Technical Service Bulletin

Subject: TRUNK BOARD STRAP COVER CRACKED / BROKEN	Bulletin No.: 09-027/18
	Last Issued: 06/01/2018

2017 CX-5 vehicles with VINs lower than JM3KF*****133707 (produced before April 11, 2017)

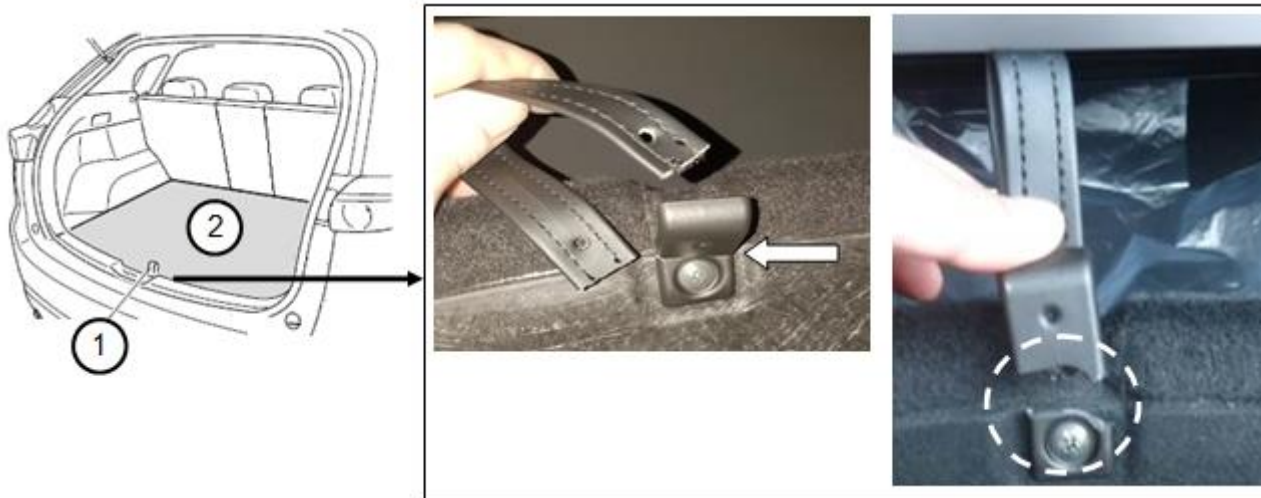
Some vehicles may have a broken trunk board (2) strap (1). This may be caused by insufficient strap cover strength. To eliminate this concern, the material of the strap cover has been changed to increase the strength.

CRACKED COVER

BROKEN COVER

REPAIR PROCEDURE

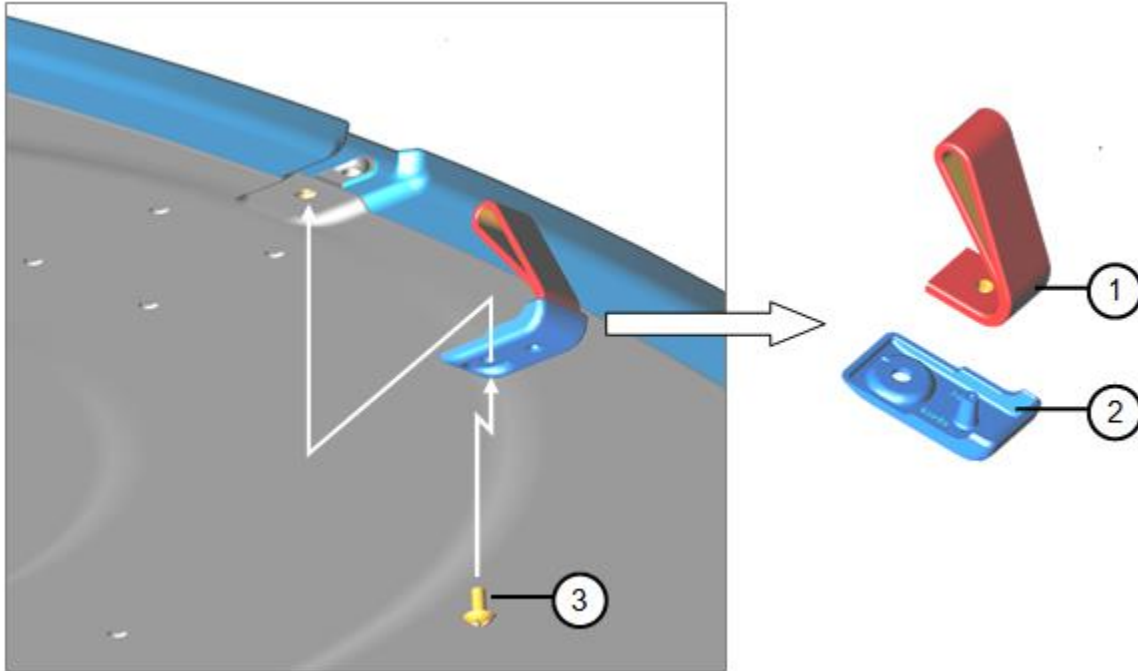
1. Verify the customer concern.
2. Replace the strap (1), cover (2) and bolt (3) with new ones.

No.	Part Name	Note
1	Strap	---
2	Cover	Modified cover with increased strength
3	Bolt	Tightening Torque: 5.5 - 6.5 Nm {48.7 - 57.5 lbf-in., 56.1 - 66.3 kgf-cm}

NOTE: If the old bolt is reused, remove the old locking agent from the threads and apply new thread locking agent.
